Issues experienced during implementation & test of new Ecdis IHO standards

- S-52 PresLib Ed 4.0.1 Chart1 (finalized)
- IEC 61174 Ed. 4.0 Preslib (still ongoing – further issues may come up)
- S-64 Ed. 3.0.0 (finalized)

a)

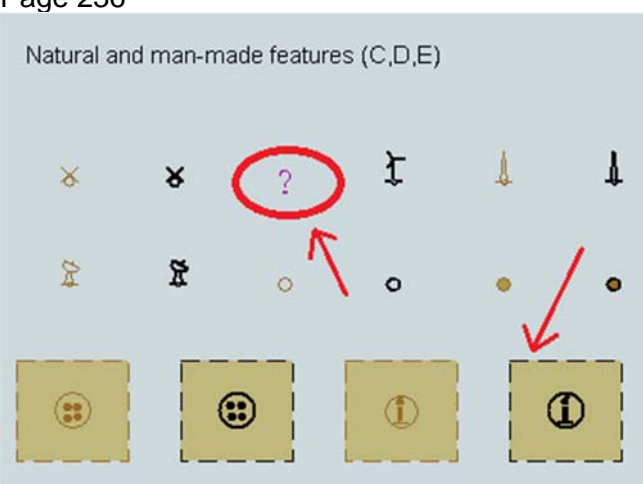
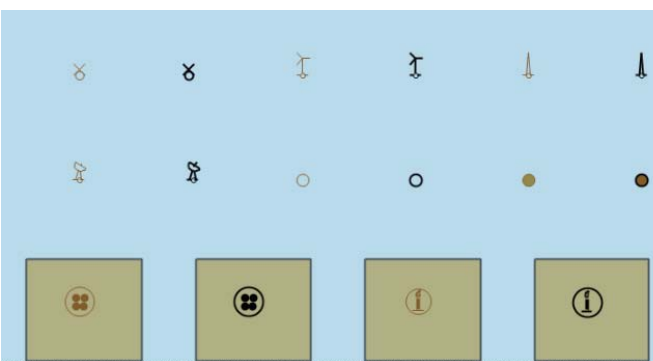
<p>Page 234</p>  <p>The number of the signal period '2s' in the light characteristic label is missing.</p>	 <p>With the Pick-Report the signal period of the light object may be displayed and verified that the display of the light characteristic label is correct.</p>
---	---

Page 238

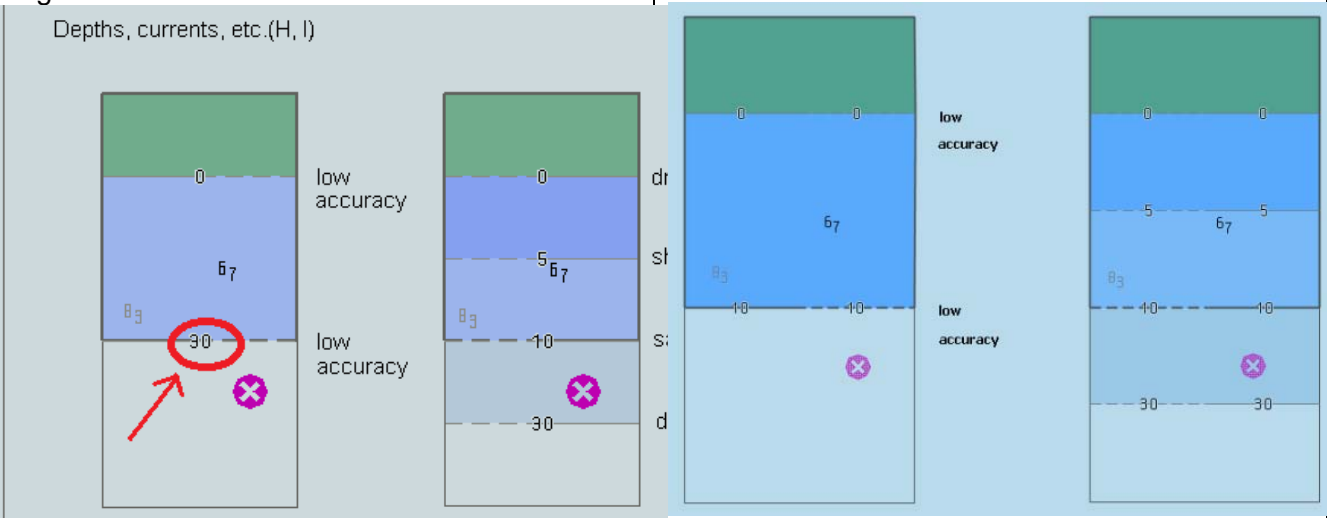
The label '30' at the Safety contour is wrong. The label must be '10'.

With the Pick-Report at the Safety contour the value of the depth contour may be displayed and verified.

Page 241

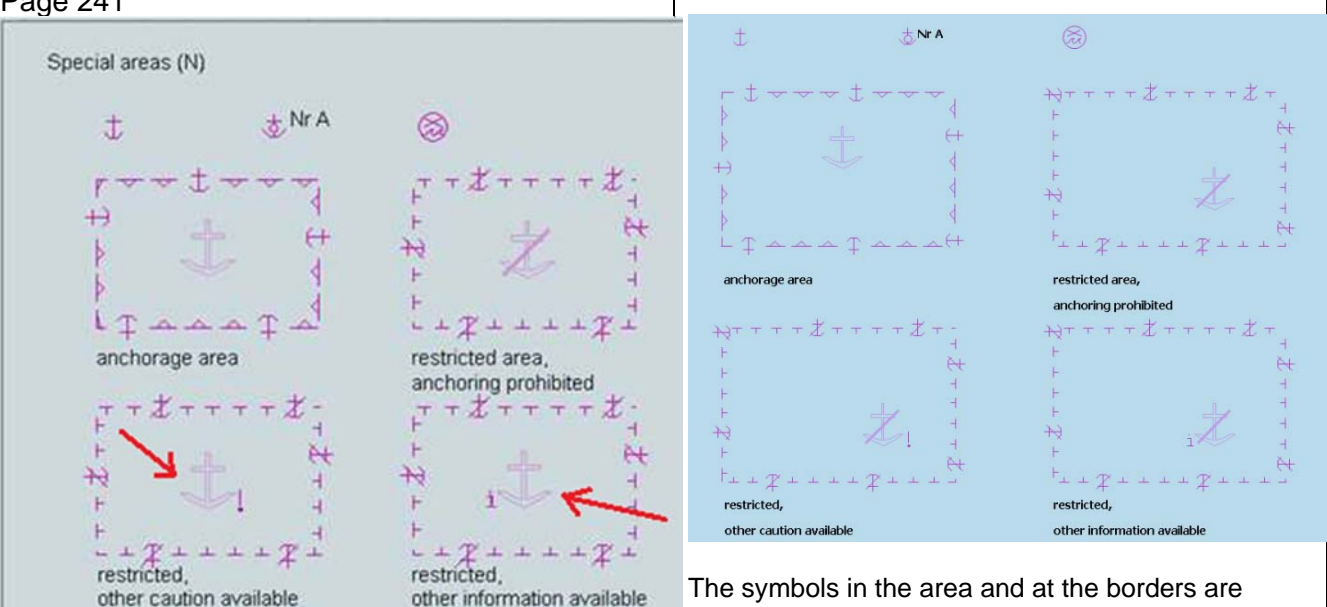
These 2 areas are of type 'Restricted area' with attribute 'anchoring prohibited', so the symbol in the area is wrong, but the symbols at the borders are correct.

The symbols in the area and at the borders are correct. (Same as with older Chart1.)

a) From the document “S-64_e3.0.0_ENC_TIM_December_Final.pdf”, Page 18: ‘Review Updates’

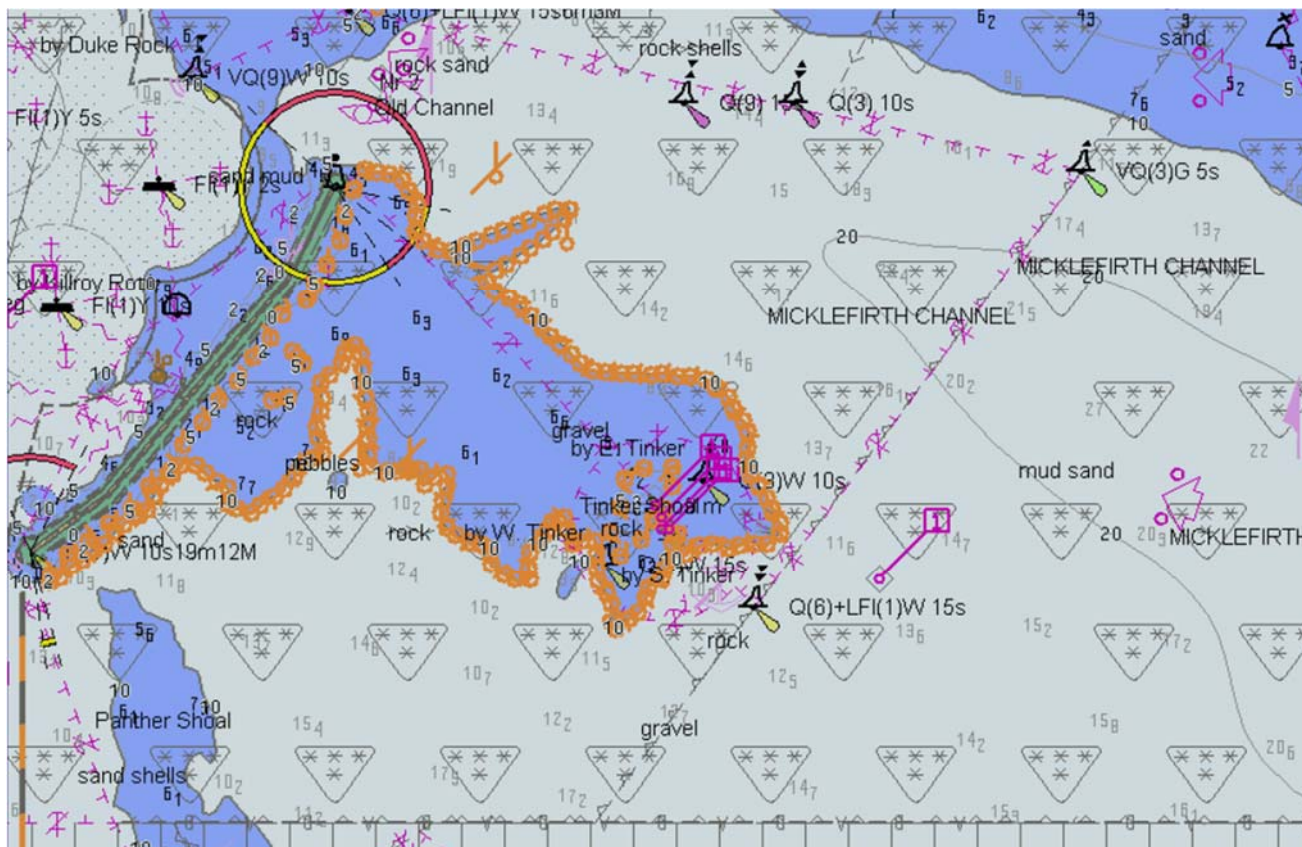
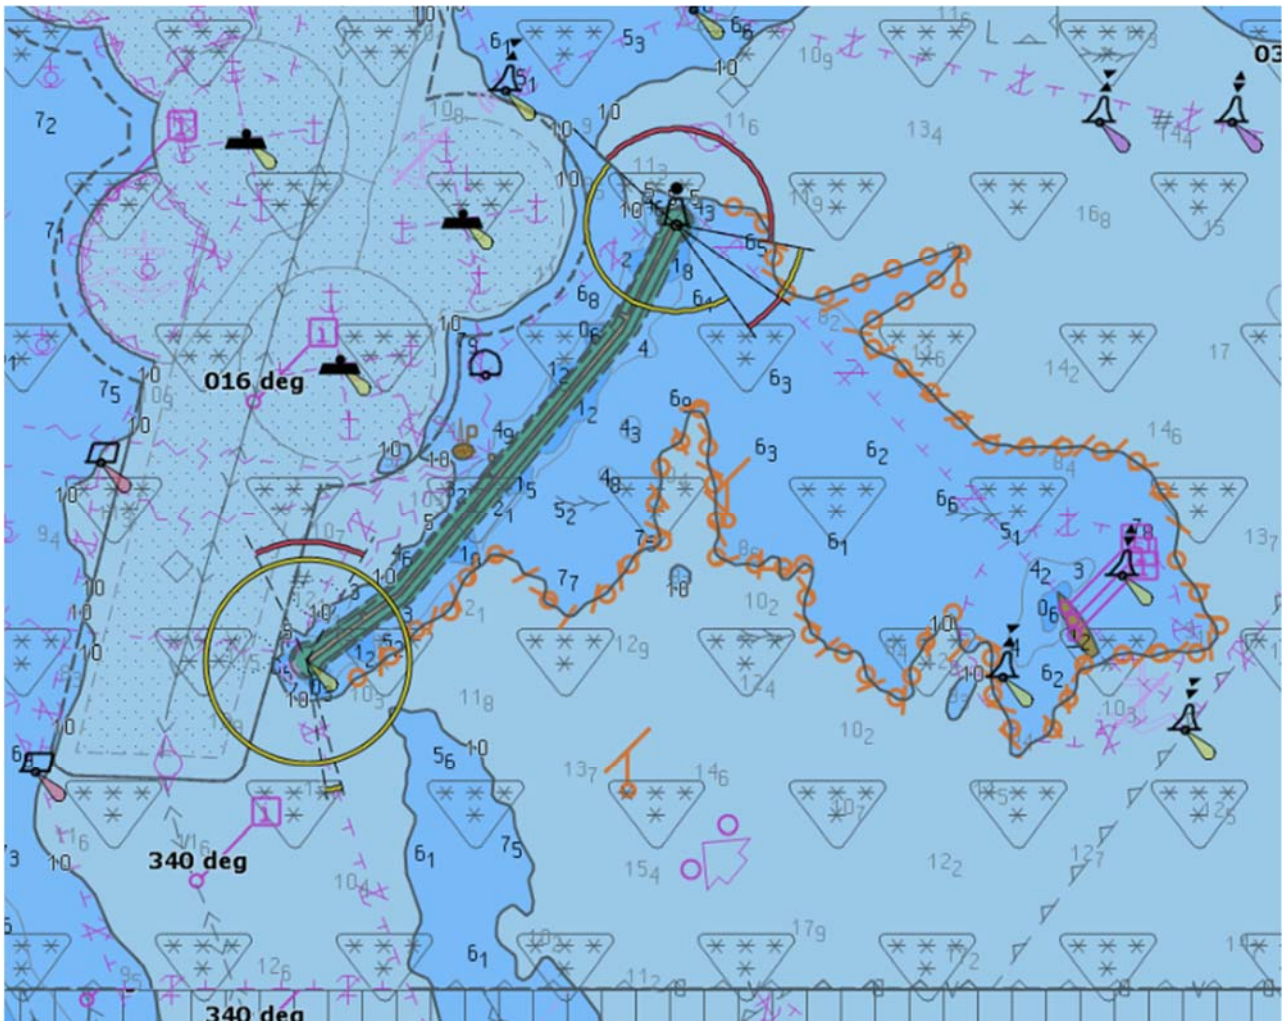
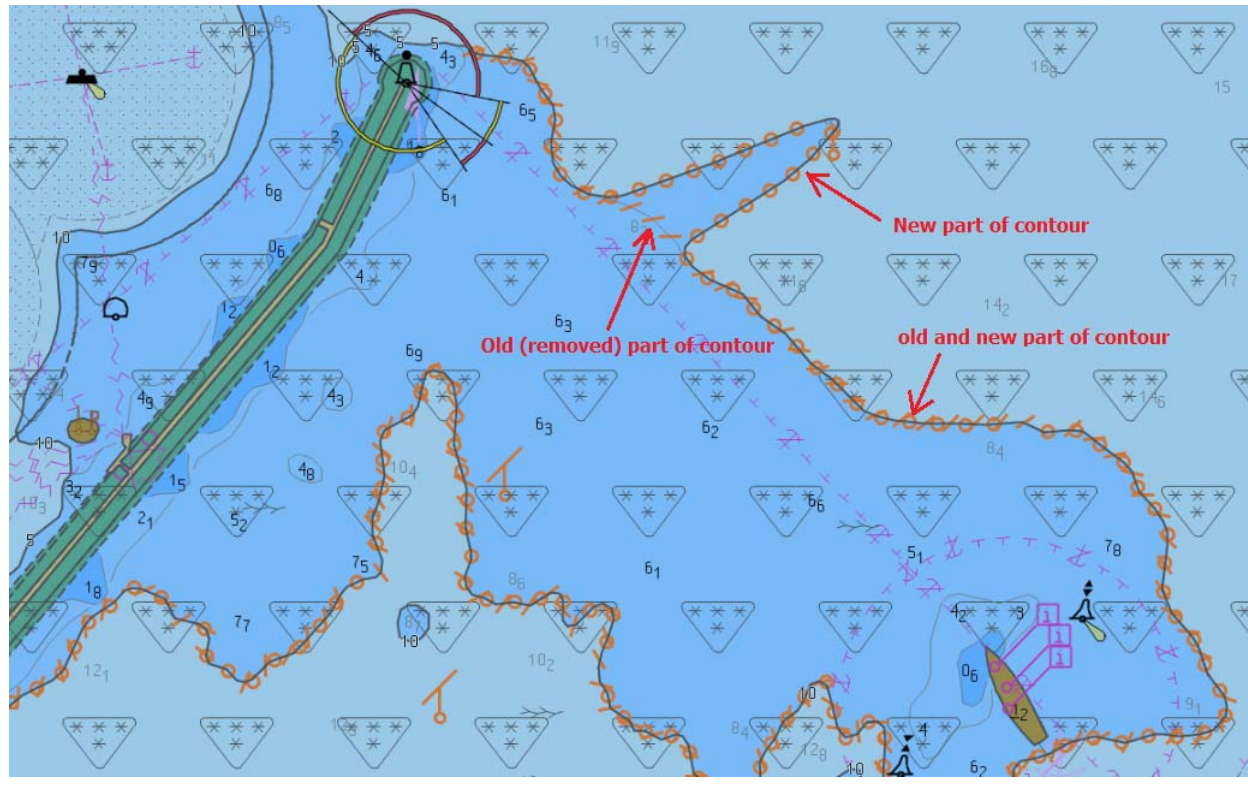
During this update the sounding of 12.8m at 32°31.75'S 060°56.85'E is replaced with a 9.4m Sounding and a part of the 10m depth contour is deleted and inserted with some new additional geographic points.

Because the modified ‘edge’ of the 10m depth contour belongs to 4 different areas, all those areas have the status ‘modified’, there is no priority.

According to “S-52 PresLib Ed 4.0.1 Part I.pdf” 10.7.2 ‘Identifying Automatic Chart Corrections On Mariners Demand’, all the modified areas should be marked with overwriting the area boundaries and a centred symbol.

This is not the case in the picture above (10-20m depth area borders are not marked) and it would also definitely clutter the screen, and indeed confuse the user.

If instead only the modified part of the area borders should be marked, then the picture above is also not correct, because the north-west border part was not modified.

In order not to confuse the user and only mark the parts of the geometry which have really been modified, the Ecdispilot Platinum will overwrite only the parts of the modified geometry lines and the modified areas only in such cases with the centered symbol.

Figure 7 LIGHTS06 conditional symbology procedure (Page 124, middle part):

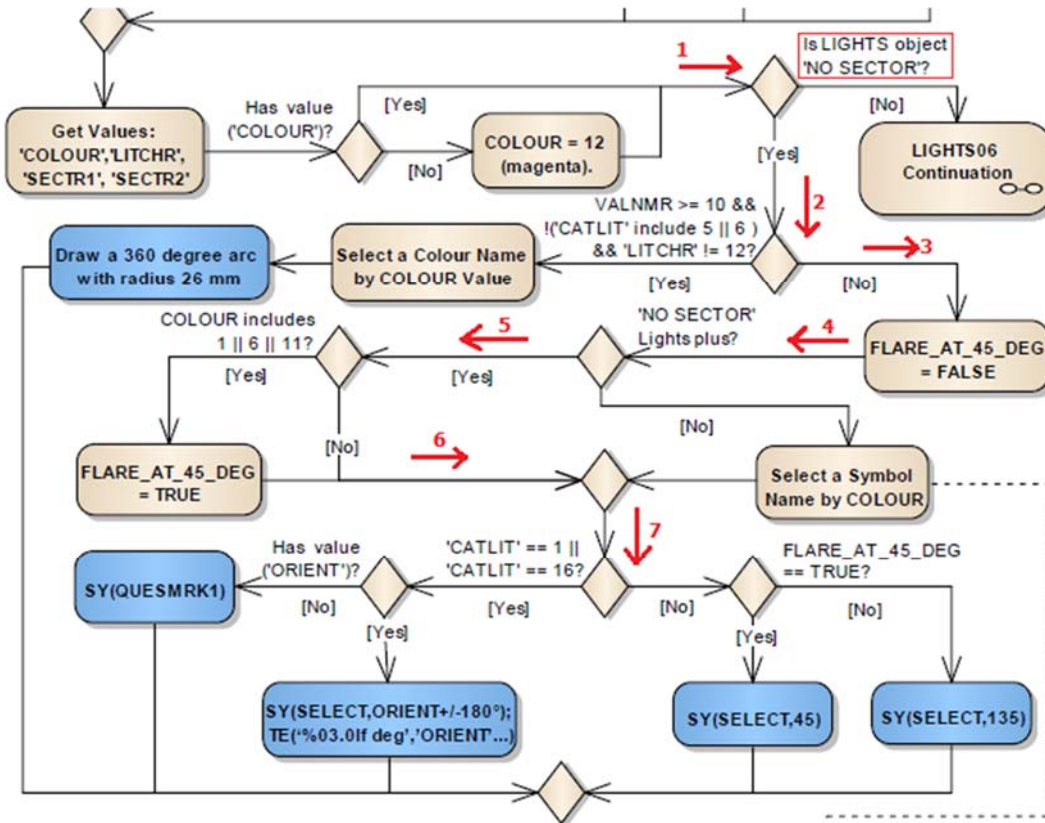
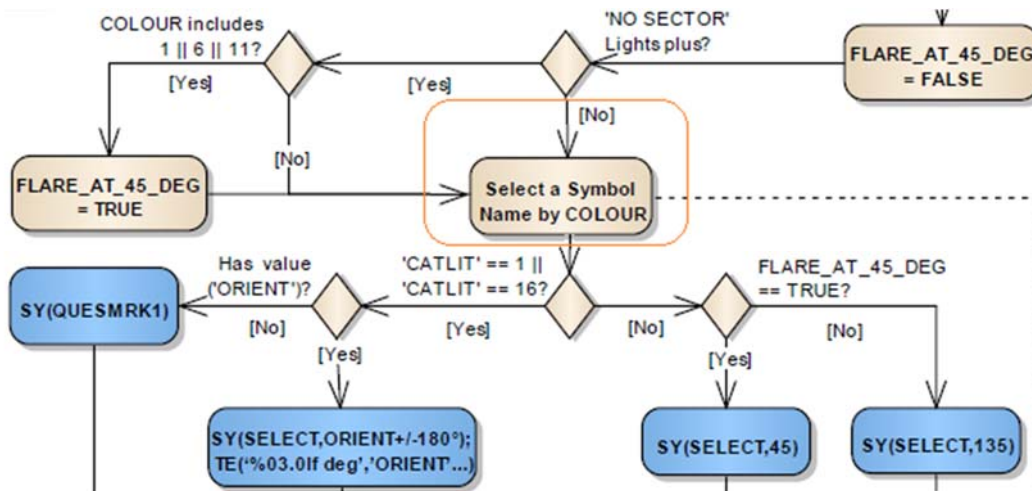
Problem 1: If the decision path is following the red arrows, then after arrow 7 there is no symbol selected for using. Next picture shows SAM Platinum ECDIS behaviour:

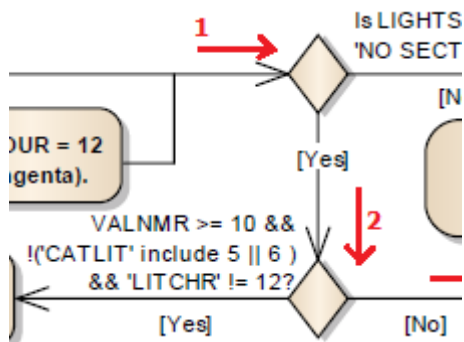
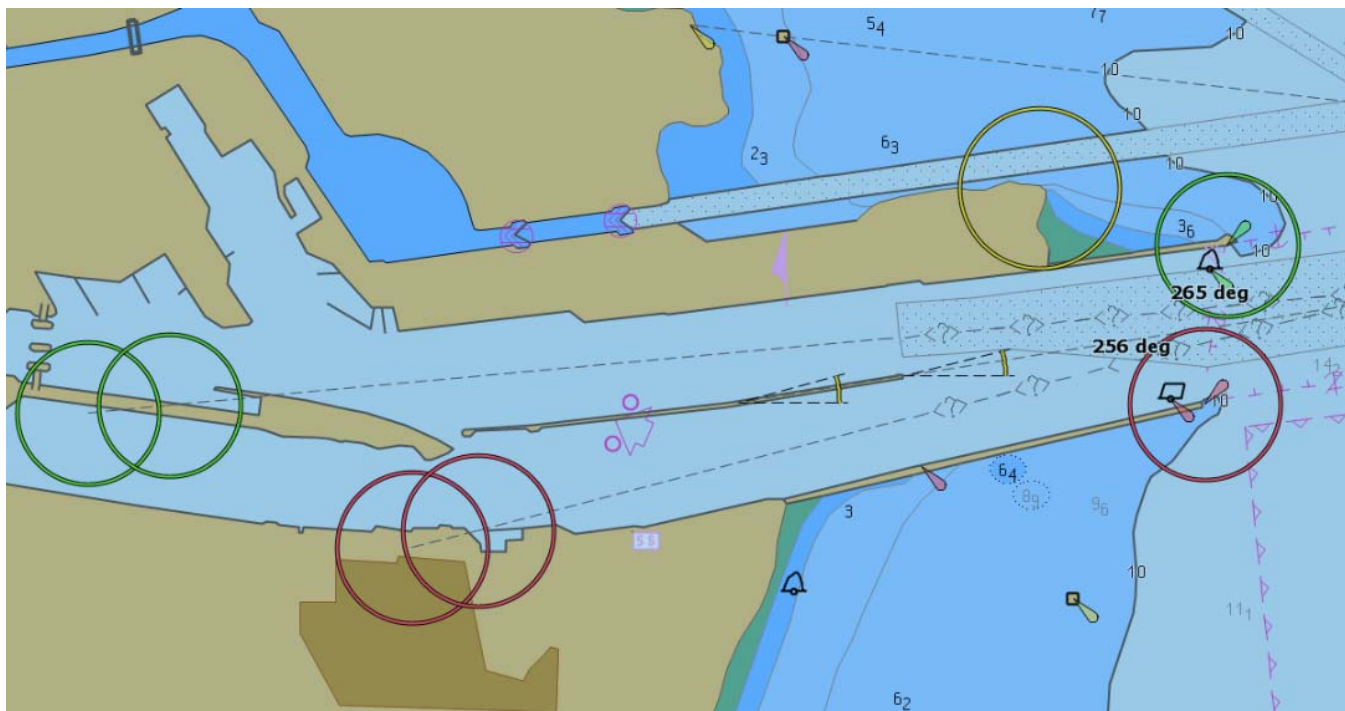
Problem 2: After the decision "Is LIGHTS object 'NO SECTOR'?" is answered with "Yes" the next check is for VALNMR >= 10 && !('CATLIT' include 5 || 6) && 'LITCHR' != 12?

If this is implemented accordingly, then a lot of lights will be displayed with a fixed 360° arc:
(S64 Test Data Set, Pos 32°36,3' S 060°53.0' E)

Following exactly the "Conditional Symbology Procedure" of Lights then some of them are drawn with the fixed size 360° arc and there is maybe no symbol at the position of the light.

Question: What is the wanted and “right” solution?
